Title: LANL Report on Northstar Facility Design Support FY21

LANL Report on Northstar Facility Design Support FY21

Keith Woloshun

Figure 2. The water jacket surrounding the target vacuum enclosure, showing the beam pipe connection and the resulting temperature profiles.

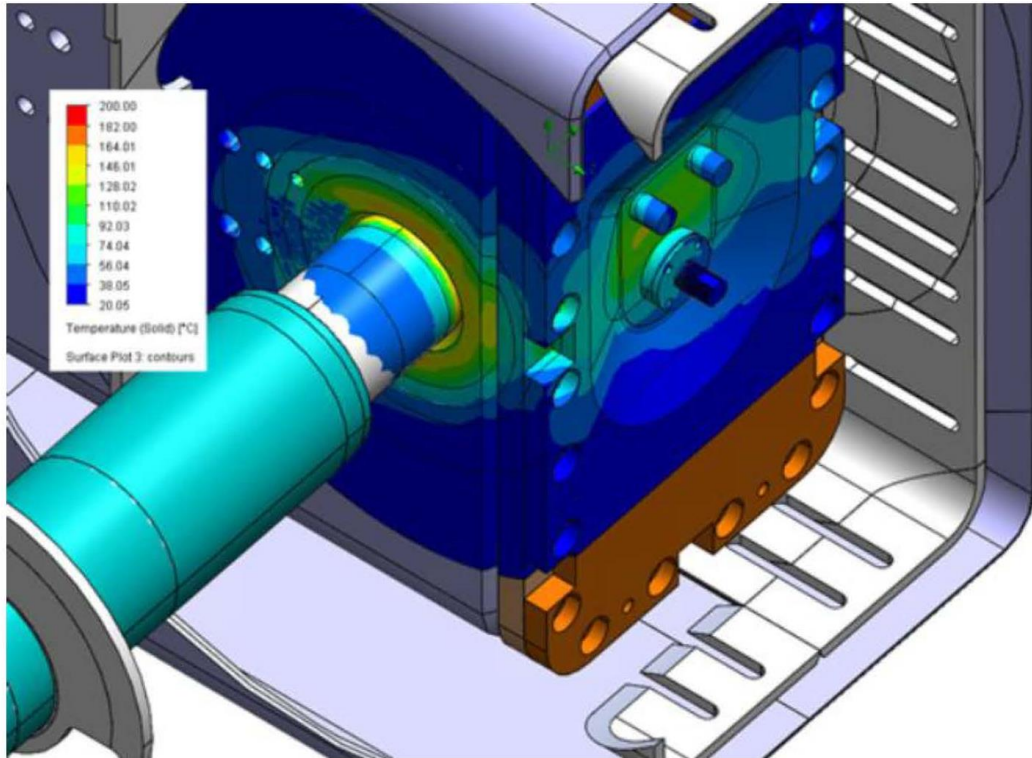
Beam heating of this jacket is highest directly along the beam line. The water flow leaving the beam pipe cooling annulus impinges at that location, then turns to follow the path toward the locating pins. The high heating in this region results in temperatures above 160 C, based on single phase water, which would cause boiling and possible further overheating if local dryout occurs. As a general rule, boiling is avoided in all regions in or near a target because of the dryout uncertainty and the difficulty and cost of repairs. This geometry and temperature profile is shown in Figure 2.

Heat flux in the region is approximately 86 W/cm^2 , quite reasonable by most standards, but the water velocity was quite low, but with a local peak of 250 W/cm^2 . Inlet water velocity was less than 2 m/s . LANL suggestion was to increase the velocity locally to 10 m/s by funneling the beam pipe water flow directly onto the region of high heat flux. 10 m/s (20 ft/s) is generally accepted maximum for steel and iron piping. This solution was adopted.

Figure 2. Lamination stack-up.

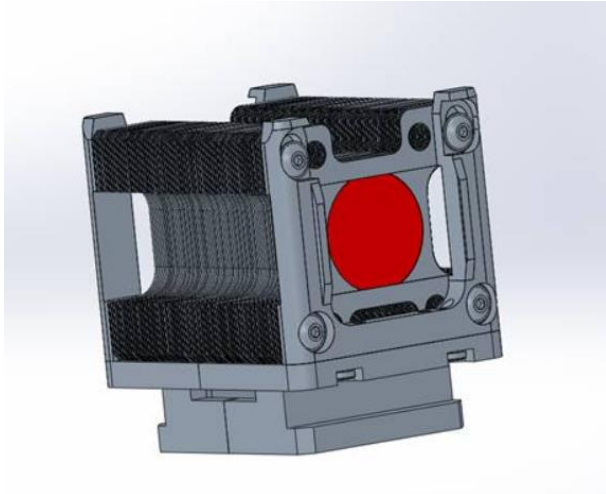
The target disks are held between laminations which are pinned together as indicated in Figure 2. Analysis showed that the outer reaches at the pins holding the stack were excessively hot. Northstar has incorporated some flow channels for improved cooling of the laminations. Analysis by engineer at ANL indicates that this is effective and sufficient. LANL will be performing similar analysis as a confirmation. Some changes to accommodate additional bypass flow in these areas may be advisable.

Figure 3. Conceptual layout of the OTR and IR cameras within the target tunnel.

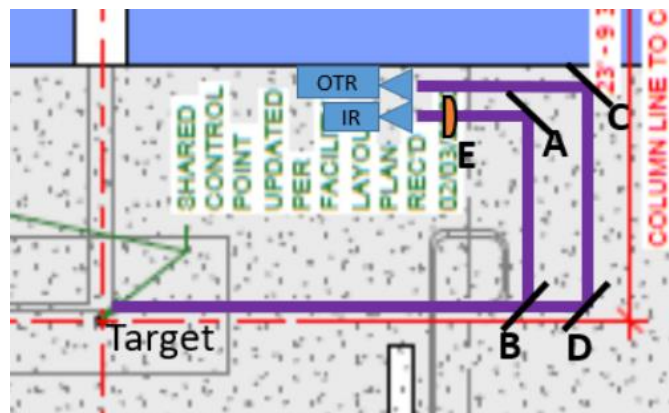
Move the cameras as far as possible from the target. For example, the distance from target to camera is increased without increasing total separation distance by flipping the camera location 180° in the view shown in Figure 3.

To simplify replacement of a camera, consider moving the camera placement into the rhodotron vault. This would eliminate mirrors A and C in Figure 3 and place the cameras on the opposite side of the blue wall in the figure. This placement is most likely also better shielded.
